06 December 2010

NATIONAL CYCLE NETWORK ROUTE 23 PROPOSAL THROUGH M3, JUNCTION 9

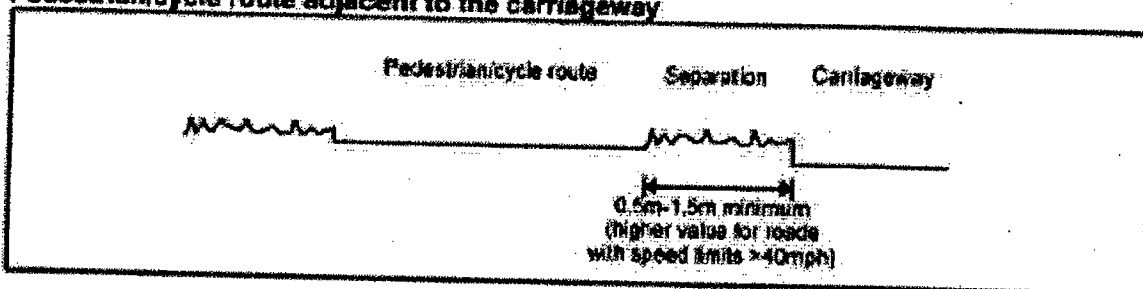
2.2.2 General Width

We are of the view that this could be brought up to the required 3m width by cutting back the vegetation and widening the footway.
